# **VILLAGE OF ARLINGTON HEIGHTS** **STAFF DEVELOPMENT** **COMMITTEE REPORT**

**Project Number:** PC 23-009  
**Project Title:** Arlington Downs Plat Amendment  
**Address:** 3400 W. Stonegate Blvd.  
**PIN:** 02-25-100-044, -048, -049  
           02-26-201-031, -034, -035

**To:** Plan Commission  
**Prepared By:** Sam Hubbard, Development Planner  
**Meeting Date:** September 27, 2023  
**Date Prepared:** September 22, 2023

#### *Rohlwing Streetscape*

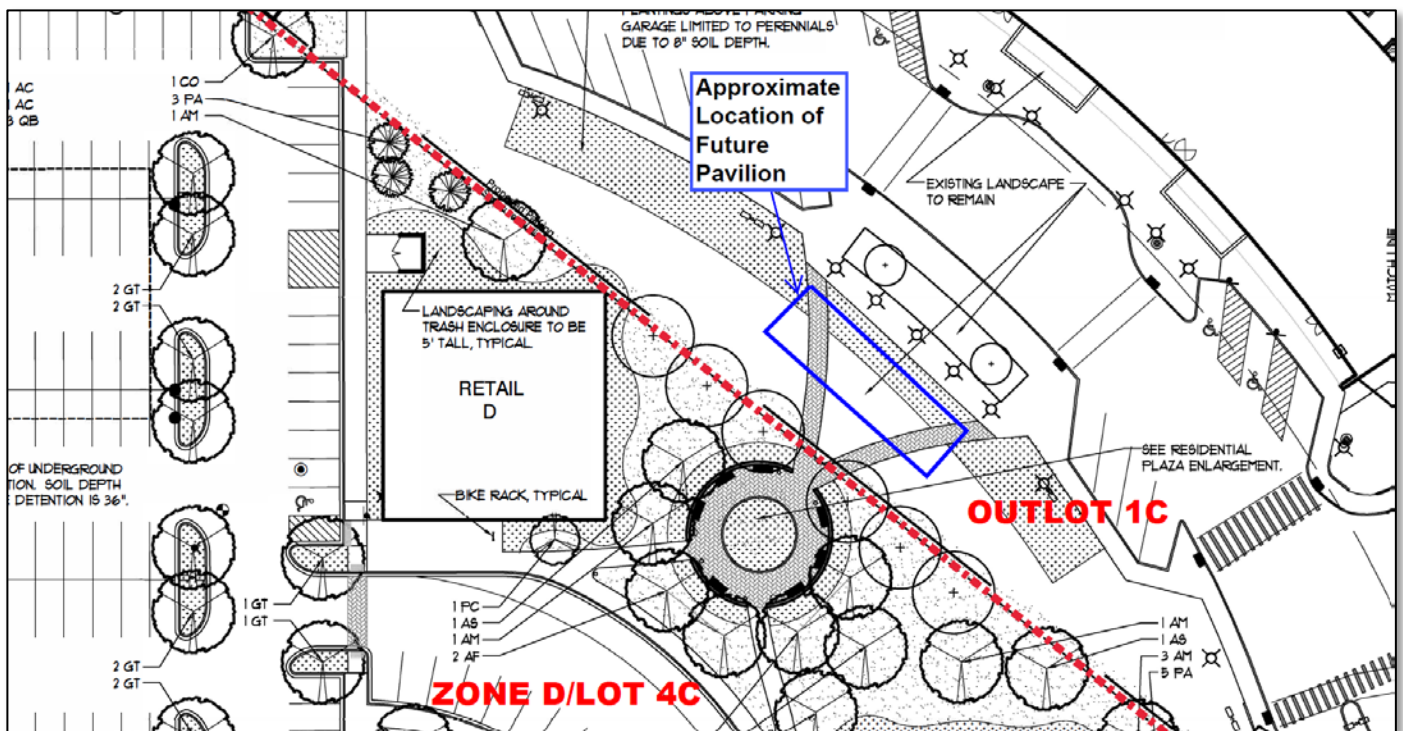
The east side of Rohlwing Road from Euclid Avenue north to Salt Creek Lane does not have a sidewalk or streetlights. During the second amendment to the PUD, which occurred in 2014, it was clarified in Ordinance 14-025 that the master developer must install the streetscape improvements along the east side of Rohlwing Road when the former water park is reoccupied. While First Ascent has now occupied the former water park, these streetscape improvements should be constructed with the first project to be developed on Lots 2A-2/Lot 16, 4B or 4C. It should be noted that the east side of Rohlwing Road is within the jurisdiction of the City of Rolling Meadows and the streetscape shall comply with all applicable requirements of the City of Rolling Meadows.

The Declarations should be revised to make it clear that whenever development occurs on Lot 2A-2/Lot 16, Lot 4B, and/or Lot 4C (whichever lot proceeds with development first) the full streetscape improvements shall be installed from Salt Creek Lane to Euclid Avenue, which shall include a pedestrian signal and crosswalk across Euclid Avenue on the east side of Rohlwing Road. The cost of these improvements shall be proportionately shared between the owners of Lots 4B, 4C, and 2A-2/16. A condition to modify the

1. The Amended and Restated Declarations shall be revised as follows:
  - a. *Rohlwing Road Streetscape Improvements*: The Declarations shall be revised to make it clear that whenever development occurs on Lot 2A-2/Lot 16, Lot 4B, and/or Lot 4C (whichever lot proceeds with development first) the full streetscape improvements shall be installed from Salt Creek Lane to Euclid Avenue, which shall include a pedestrian signal and crosswalk across Euclid Avenue on the east side of Rohlwing Road. The cost of these improvements shall be proportionately shared between the owners of Lots 4B, 4C, and 2A-2/16.

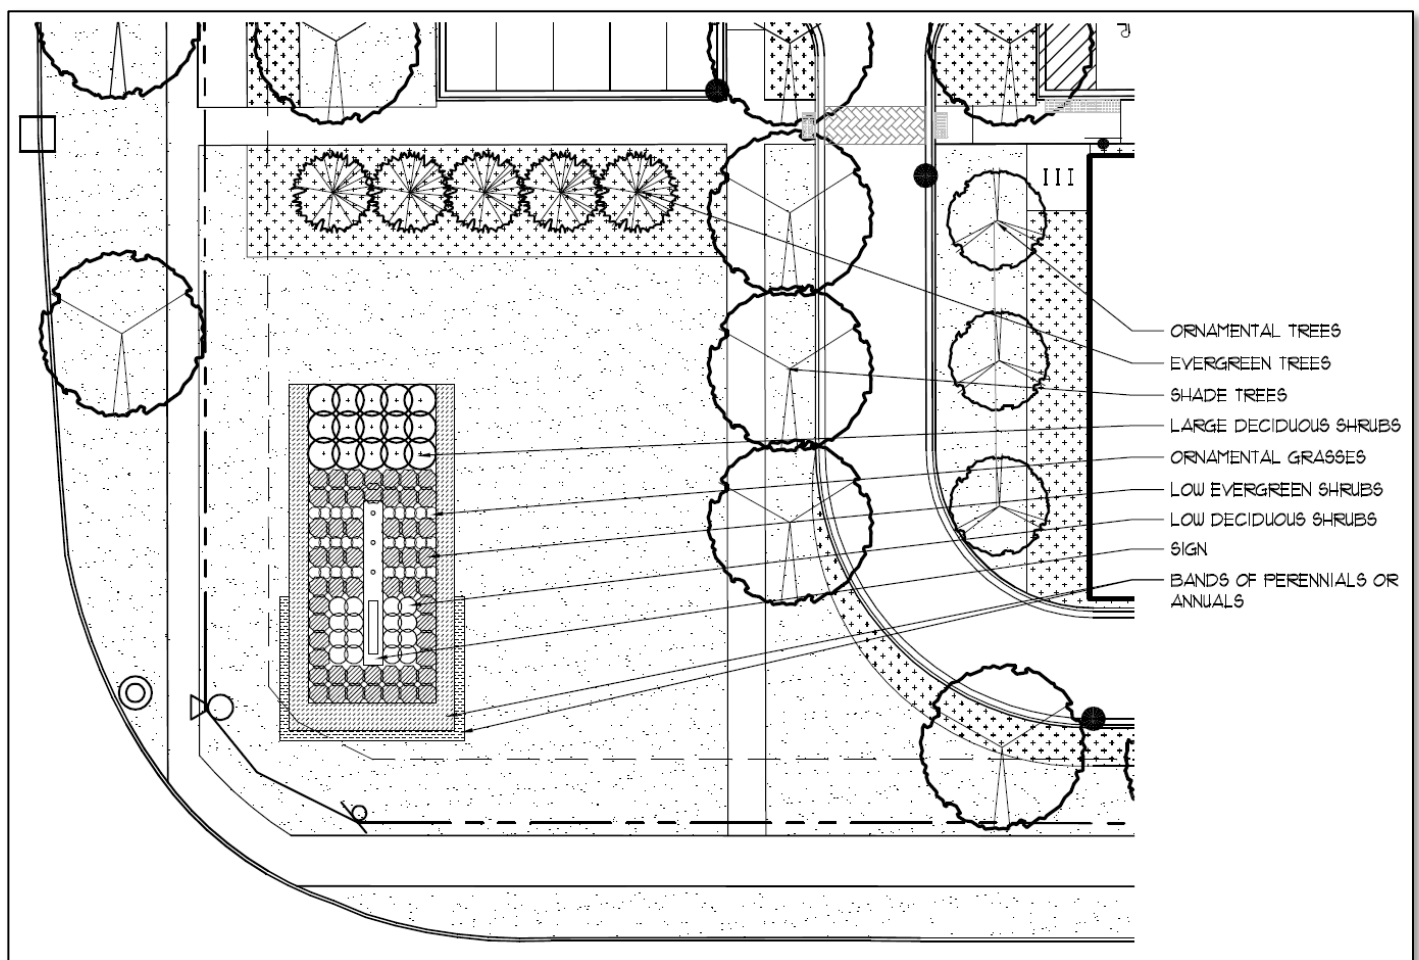
To the southwest of the One Arlington Tower there is a partially completed pavilion, which has 8 stubbed columns that are anchored into the roof of the underground garage below. These columns are meant to accommodate a future pavilion structure, which was a component of the larger plaza area that would be located in “Zone D” (now known as Lot 4C) and would function as a pedestrian pathway between the One Arlington Tower and the commercial uses in Zone D/Lot 4C. However, the pavilion columns are located on proposed Outlot 1C, which lot will be transferred to the Master Association. The revised declarations do not make it clear who is responsible for completing the pavilion area, although they do assign future maintenance costs for the pavilion to the Master Association. The Declarations state that the Master Association will “coordinate final pavilion design” with the Lot 4C owner when a development is proposed on that lot (which will include the portion of the plaza area that falls on Lot 4C). The most recent approved development concept and lot lines/future improvements are shown below:

While it makes sense that the pavilion would be completed with the associated plaza on Lot 4C, the Declarations should make it clear that Lot 4C has the authority to enter upon Outlot 1C to complete construction of the pavilion and any elements of the plaza that fall on Outlot 1C. A condition of approval to add this language to the revised Declarations has been recommended below.

- d. *Plaza/Pavilion*: The Declarations shall be revised to allow any of the other lot owners the right to construct the pavilion and any elements of the plaza area that fall within the boundaries of Outlot 1C.

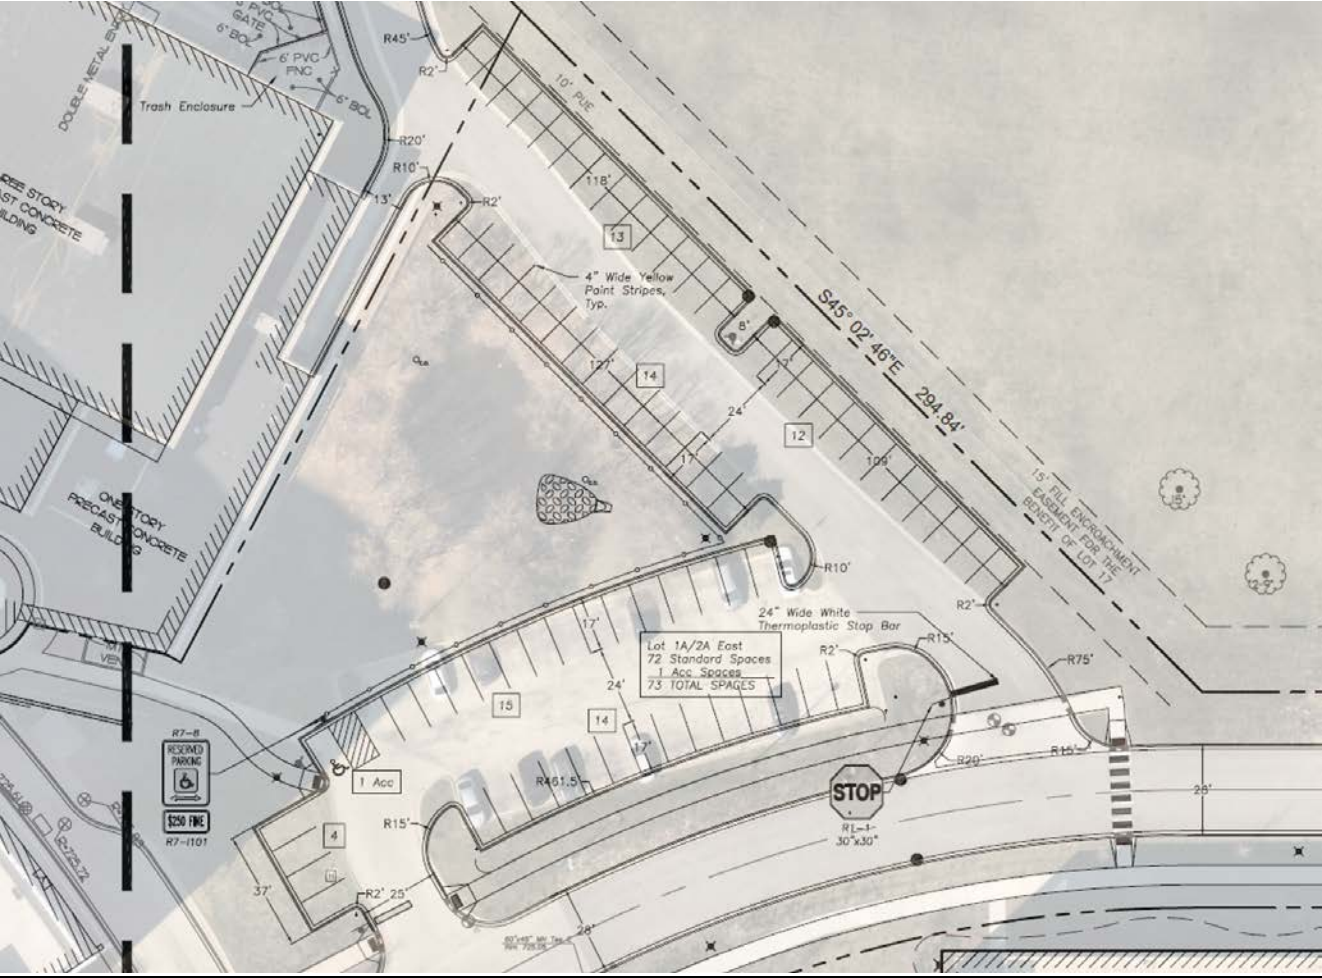
Since its original approval, all iterations of this PUD have included a Village Entry Sign at the corner of Euclid Avenue and Rohlwing Road, which was to be installed by the master developer. Per the most recent 2018 PUD amendment, the conceptual design for this entry feature is approved as generally shown below (it should be noted that Ord. 15-049 requires review and approval of a finalized design for this entry feature prior to construction):

The proposed Declarations assign the construction, cost and future maintenance obligations for this sign to the owner of Lot 4C. While the sign falls within the boundaries of Lot 4C, the original PUD was structured to

require construction of this sign when development in “Zone D” began, which zone consists of Lots 4B and 4C. The Declarations must be revised to clarify that this sign shall be constructed when development occurs on either Lot 4B or Lot 4C (whichever comes first), and that the cost of construction of this sign shall be shared between the owners of Lots 4B and 4C.

- f. *Village Entry Sign*: The Declarations shall be revised to clarify that the Village Entry Sign shall be constructed when development occurs on either Lot 4B or Lot 4C (whichever comes first), and that the cost of construction of this sign shall be shared between the owners of Lots 4B and 4C.

**Exhibit I – Land-banked Parking Areas**

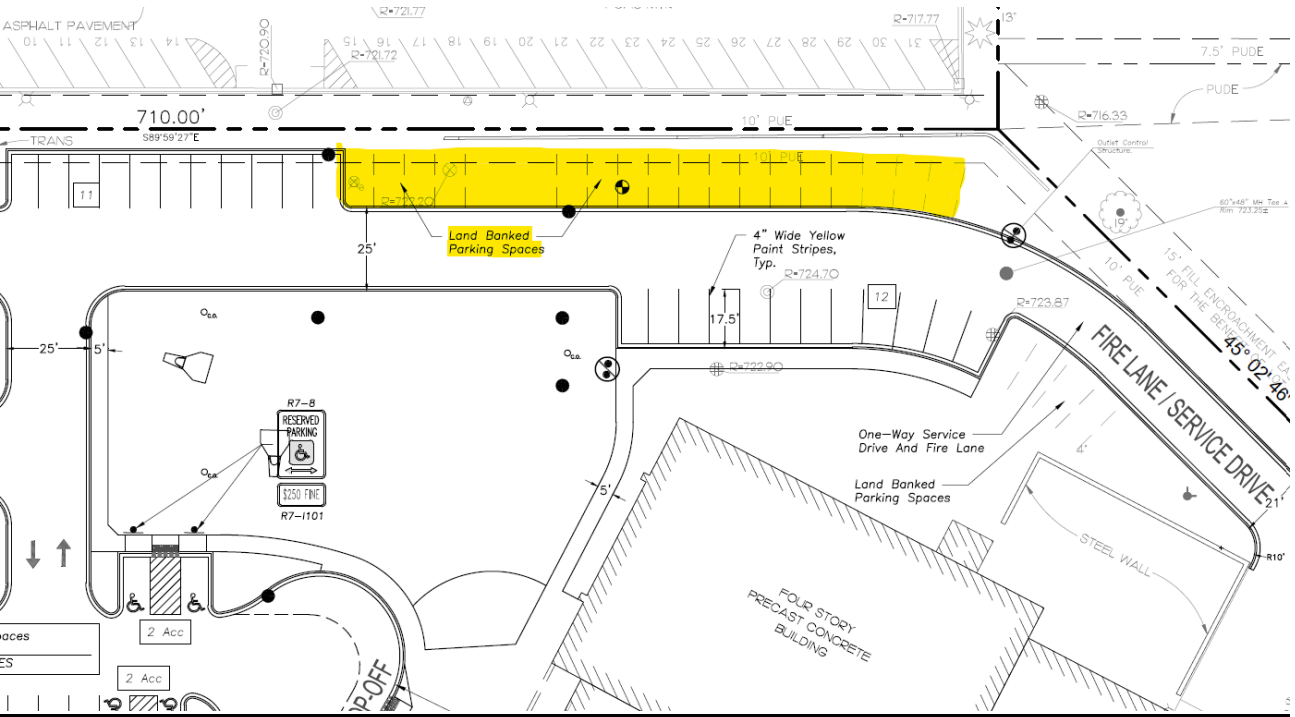
There are two areas of land-banked parking within the PUD, one located on Lot 2A-1, and the other on proposed Lot 1B. These land-banked parking areas are generally depicted within **Exhibit I** at the end of this report. Should the Village observe a parking shortage on the site, the land-banked parking areas would need to be constructed, and the Declarations should make it clear that the property owners of each lot would need to bear the cost of construction for this land-banked parking should the Village determine that it is necessary.

- c. *Land-Banked Parking*: The Declarations shall be revised to clearly state that the owners of Lots 1B and 2A-1 shall bear the cost of construction of the land-banked parking on their respective lots should it be determined by the Village that there is a parking shortage occurring within the PUD.
